FILE P. I. No. 0007950, Douglas County **OFFICE** Preconstruction
 CSSTP-0007-00(950)
 Chapel Hill Road at Central Church Road/
 Bomar Road Intersection Improvements **DATE** March 6, 2006

SUBJECT APPROVED PROJECT CONCEPT REPORT

DESCRIPTION: Chapel Hill Road at Central Church Road/Bomar Road Intersection
Improvement

MINUTES OF MEETING

STATE OF GEORGIA
 DEPARTMENT OF TRANSPORTATION
 OFFICE/DISTRICT 7 DESIGN
TYPICAL SECTIONS

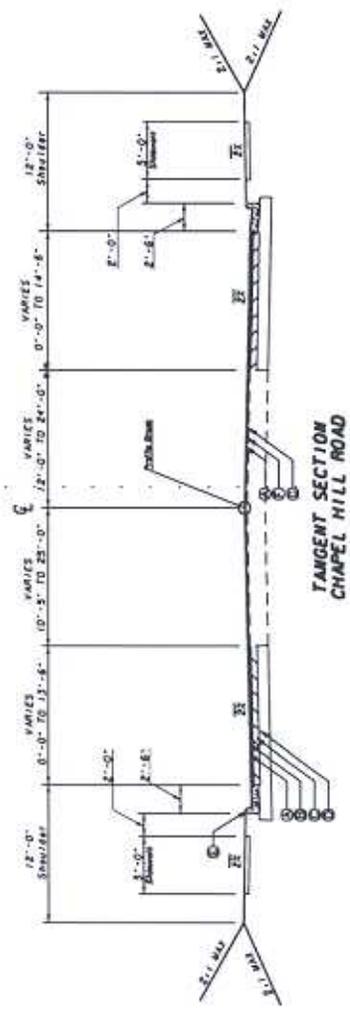
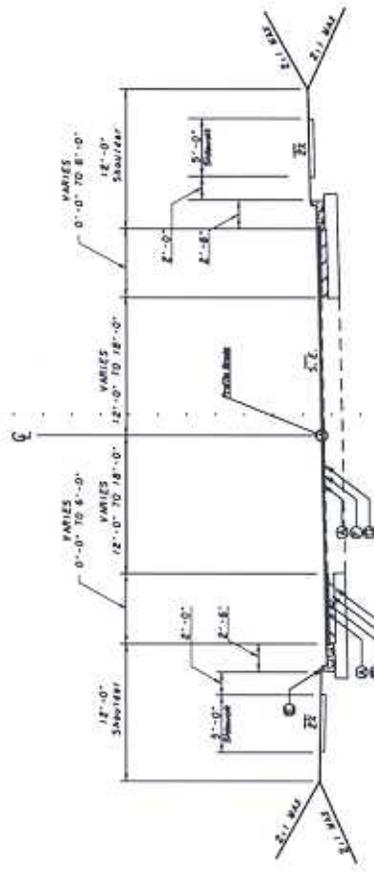
25. Ted Crabtree asked if the shoulder width on the typical section should be increased from 10 feet as shown in the draft concept report. After a brief discussion, it was decided that the typical sections would be revised to show a 12-foot shoulder.
